A Review of Evergy Metro and Evergy Missouri West 2023 Annual IRP Update

Chelsea Hotaling, Energy Futures Group

The Council for the New Energy Economics (“NEE”)

August 2023

Figure 2. Producer Price Indices for Key Inputs to CCs Compared to CPI²⁵

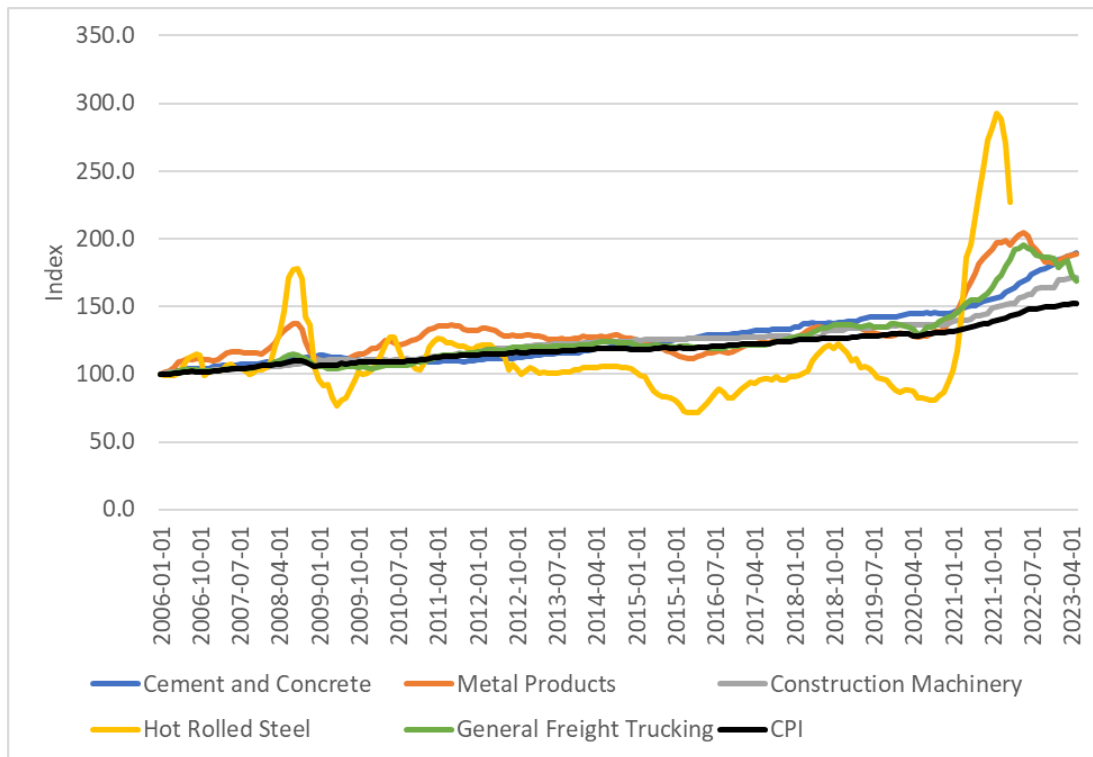
Producer Price Indices for certain inputs into combined cycle facilities also suggest that inflation is a serious risk. As shown in Figure 2, indices for Cement and Concrete, Metal Products, Construction Machinery, Hot Rolled Steel, and General Freight Trucking have increase materially at rates higher than inflation for over a year now.

Increases in these inputs in the mid 2000s were direct contributors to price increases for coal-fired power plants of 30 – 50% or more. Natural gas plants also require significant amounts of structural steel, wiring, piping, cement, grating, etc. This balance of plant material pricing is generally estimated off of index pricing and if fixed, does not become so until the final contract to construct the facility is signed. The balance of plant can be a significant portion of construction costs, anywhere from 40-60%.

In sum, the cost estimate assumed for the combined cycle units (and likely the combustion turbines) is significantly understated and cannot be relied upon to select a least cost, optimal plan.
